**AGENDA**  
**City of Monona Plan Commission**  
**Monona Public Library - Municipal Room**  
**1000 Nichols Road, Monona, WI**  
**Monday June 27, 2016**  
**7:00p.m.**

**PLAN COMMISSION STAFF REPORT  
CITY OF MONONA**

Enclosed is the revised existing, site, and grading/erosion control plan set for The Kilgust Drive Building Addition for Wiedenbeck, Inc. The plans have been revised to address comments contained in your letter dated June 7<sup>th</sup>. The responses to comments are as follows:

EXISTING SITE PLAN  
 SHEET: C-1  
 DATED: JUNE 17, 2016

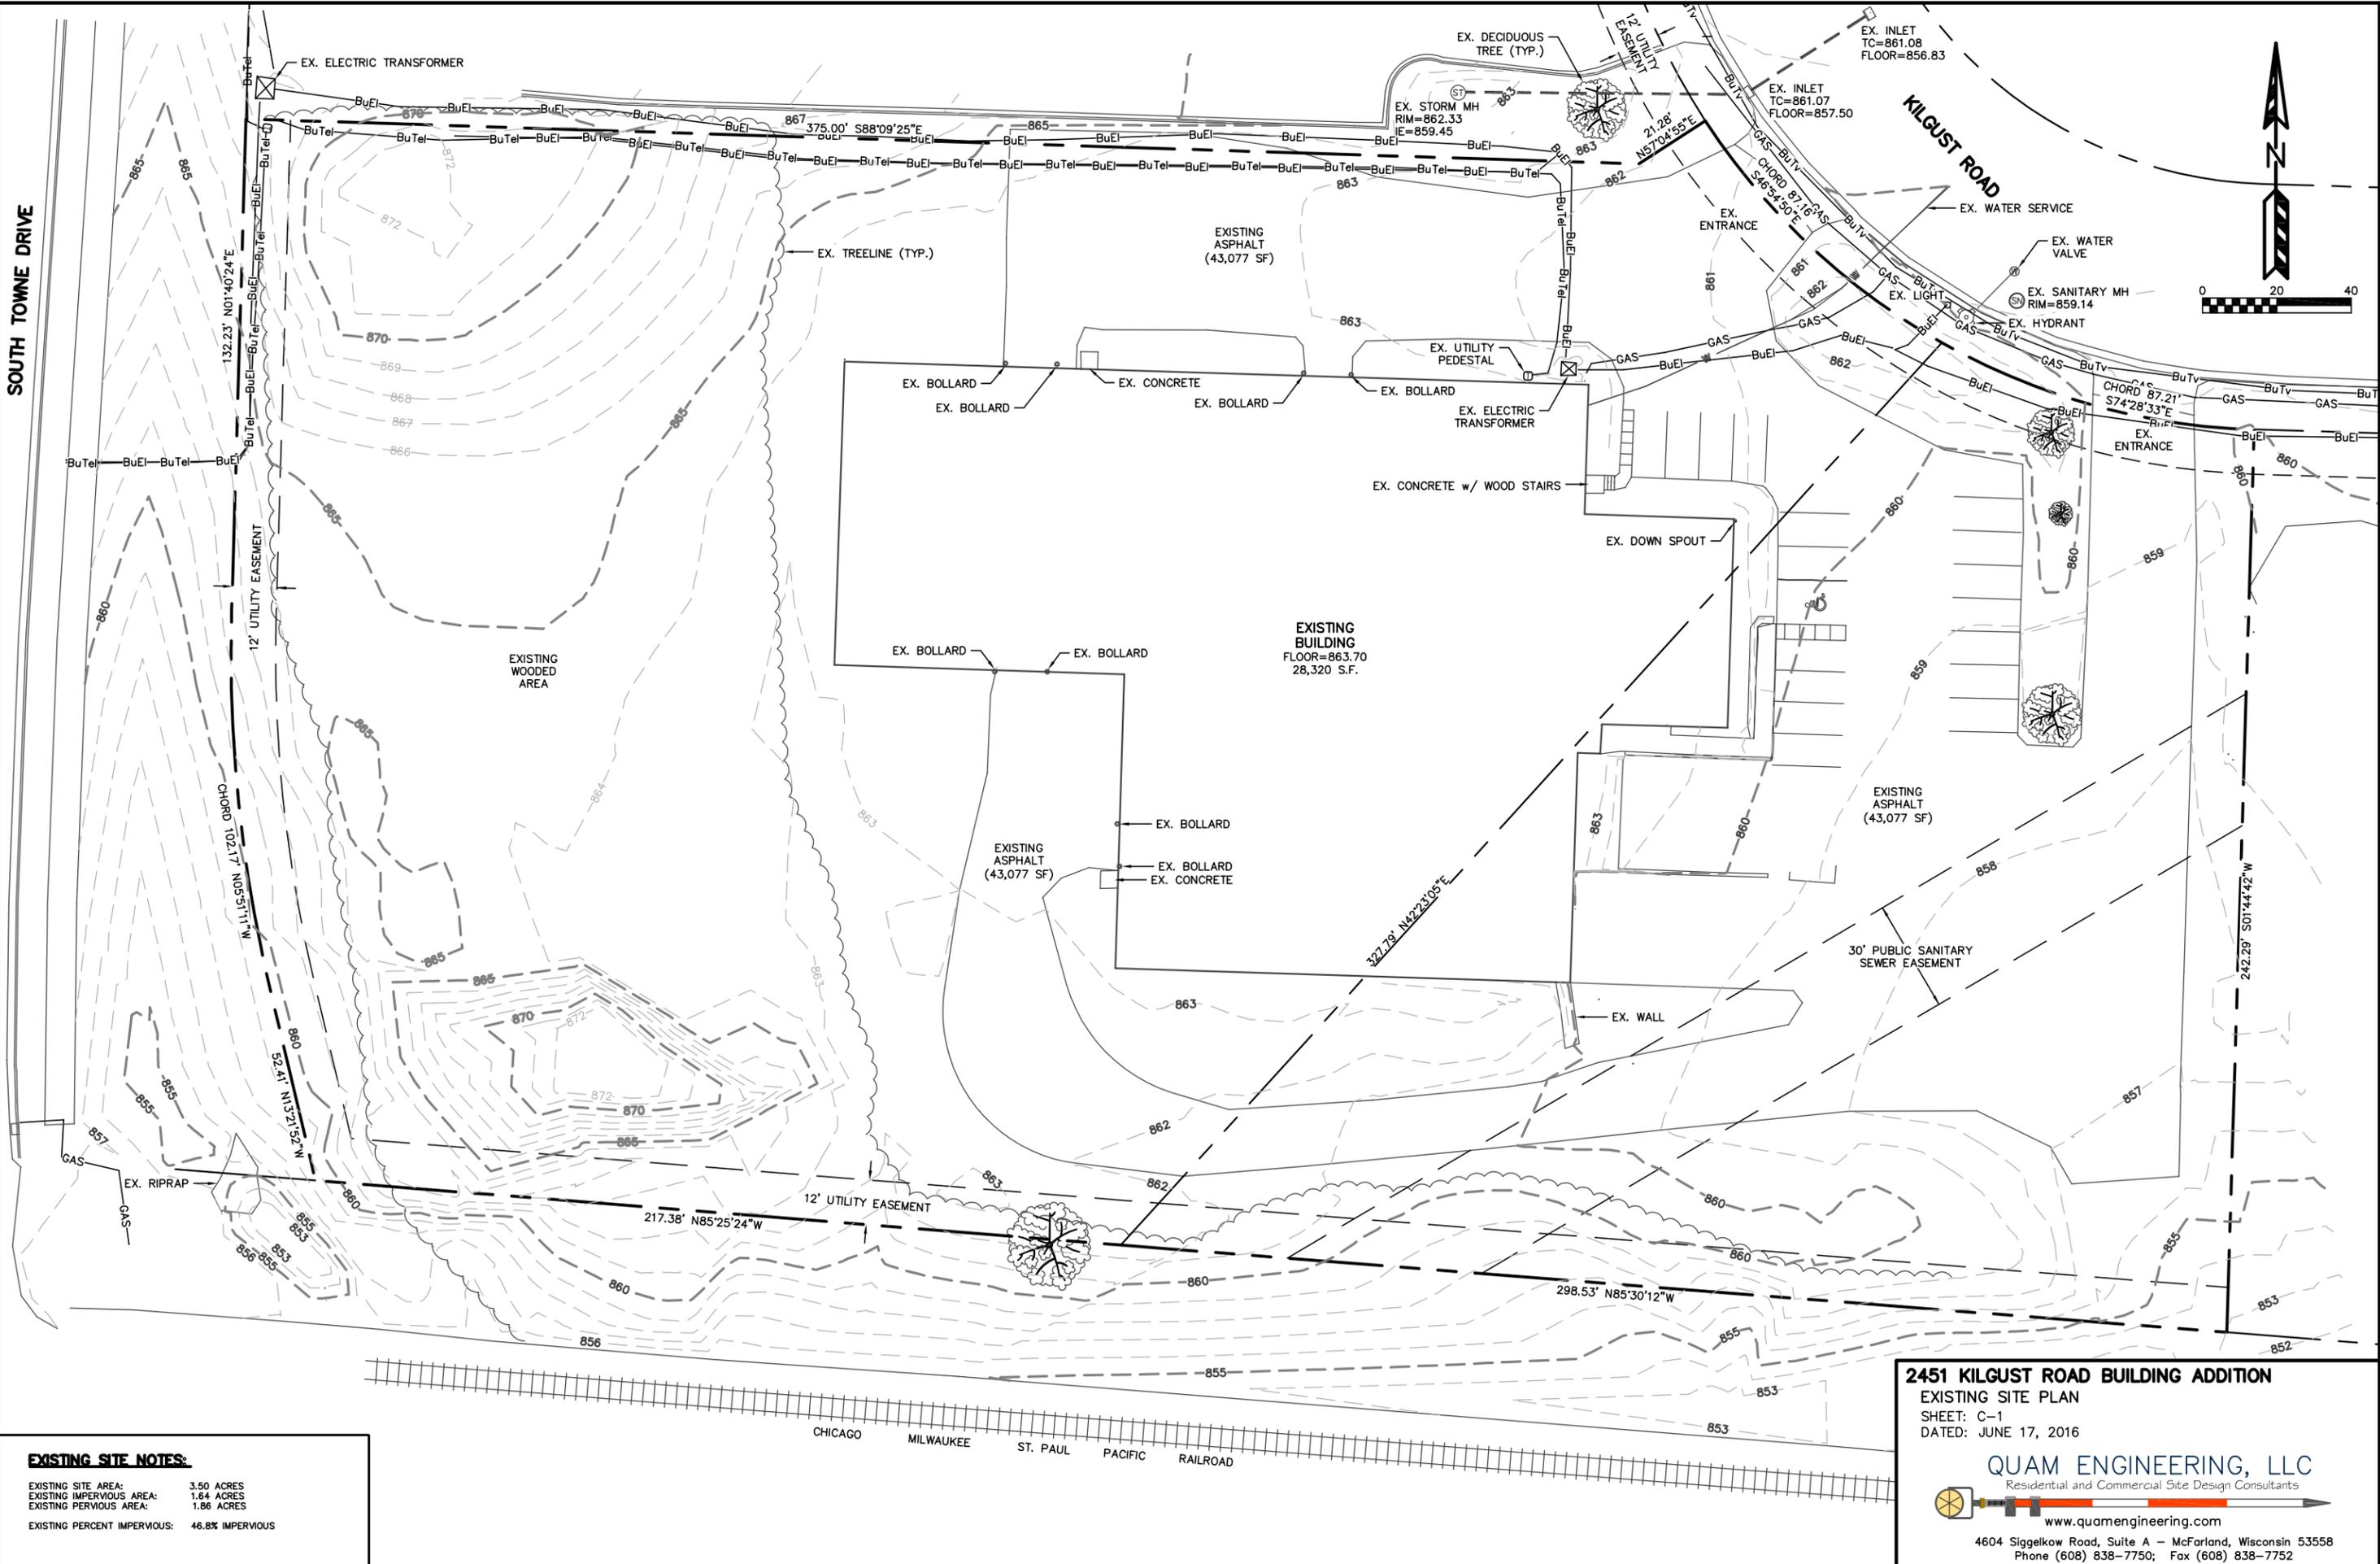
- *The existing conditions pervious and impervious areas as well as the percent impervious area should be indicated on the "Existing Site Plan".*  
**Impervious areas have been added to the Existing Site Plan.**

CIVIL SITE PLAN  
 SHEET: C-2  
 DATED: JUNE 17, 2016

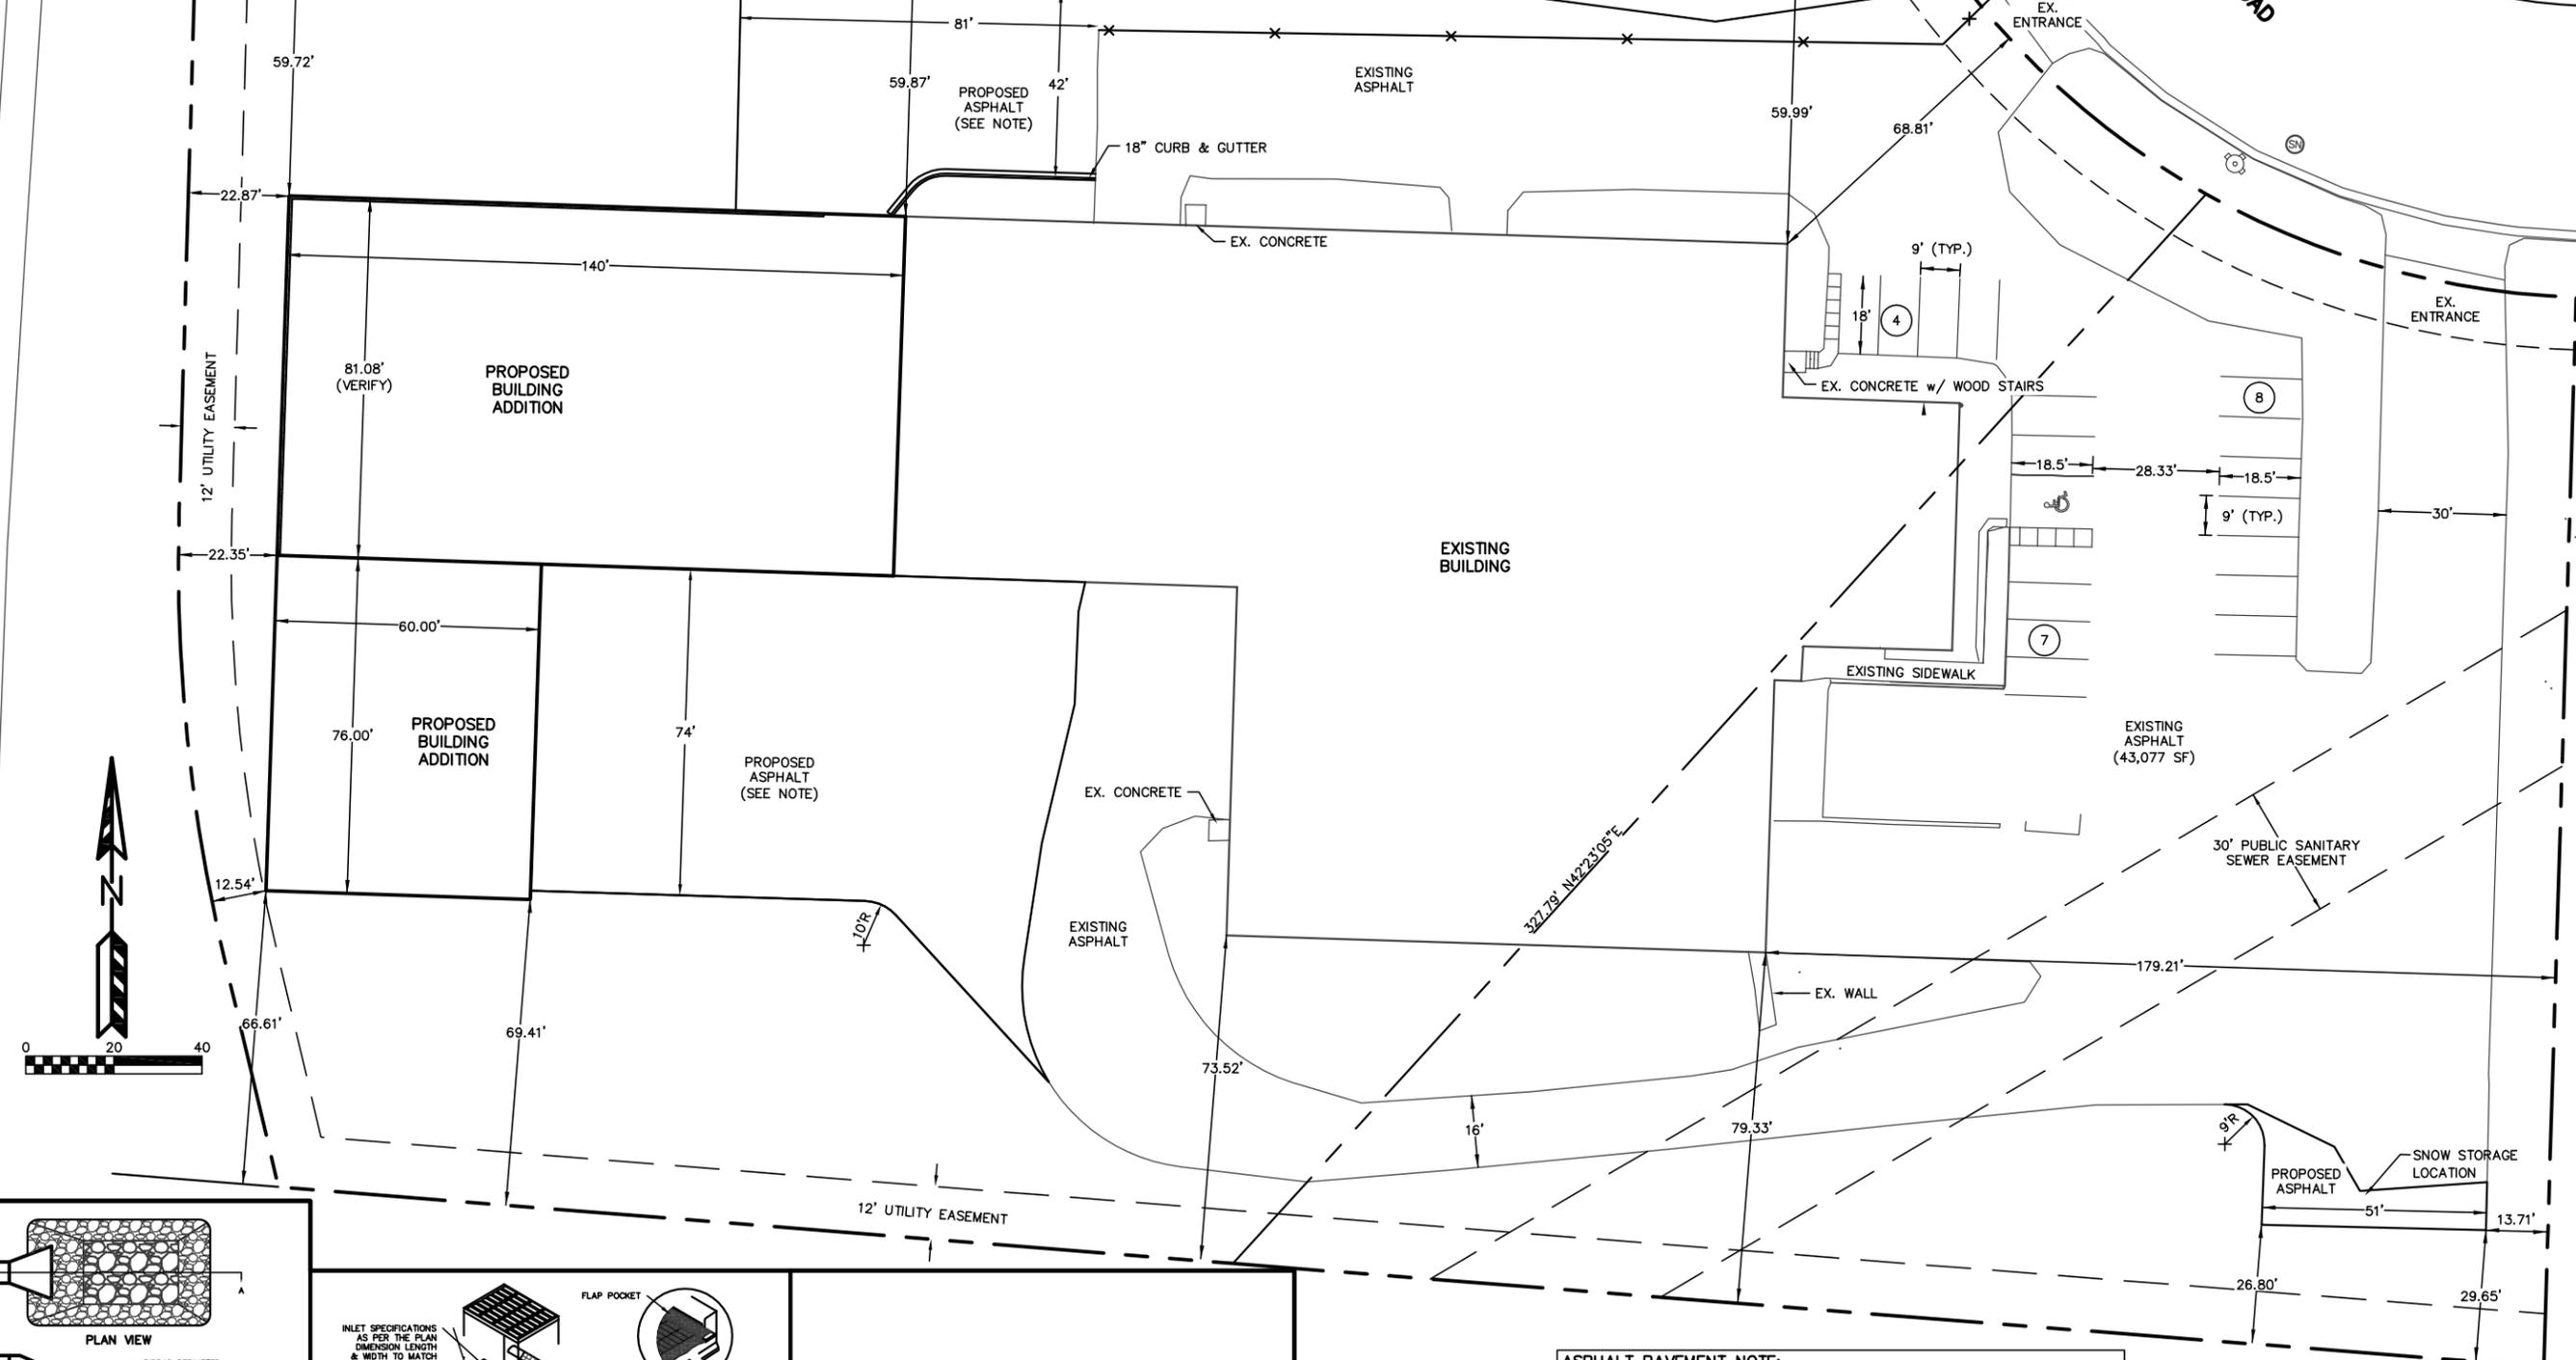
**There are no proposed parking stalls.**
- *The proposed pavement structure should comply with the requirements of Section V.(a) of Appendix A - Site Design Standards for Parking, Landscaping and Lighting, Title 13 of the City's Code of Ordinances. The plans should be revised to show the proposed pavement structure.*

- *A silt sock installation details should be added to the plans.*  
**The detail has been added to the Site Plan.**
- *The erosion control plan should include inlet protection for on-site and nearby off site inlets.*

- *An inlet protection detail should be added to the plans for each type of inlet protection to be installed.*  
**The Type D Inlet Protection detail has been added to the Site Plan.**

**The medium riprap with fabric dimensions are shown on the Grading and Erosion Control Plan and the detail has been added to the Site Plan.**
- *A storm sewer outfall rip-rap detail should be added to the plans.*

**The note "PAVEMENT SHALL CONSIST OF 10" CRUSHED AGGREGATE, 2" ASPHALT BINDER, AND 1 1/2" ASPHALT SURFACE IN CONFORMANCE WITH THE REQUIREMENTS OF SECTION V.(A) OF APPENDIX A - SITE DESIGN STANDARDS FOR PARKING, LANDSCAPING, AND LIGHTING, TITLE 13 OF THE CITY'S CODE OF ORDINANCES." has been added to the Site Plan.**

**The riprap detail has been added to the Site Plan**
- *The “Rock Check Dam” detail should be revised to show geotextile fabric Type R beneath the rock check to protect it from being undercut.*
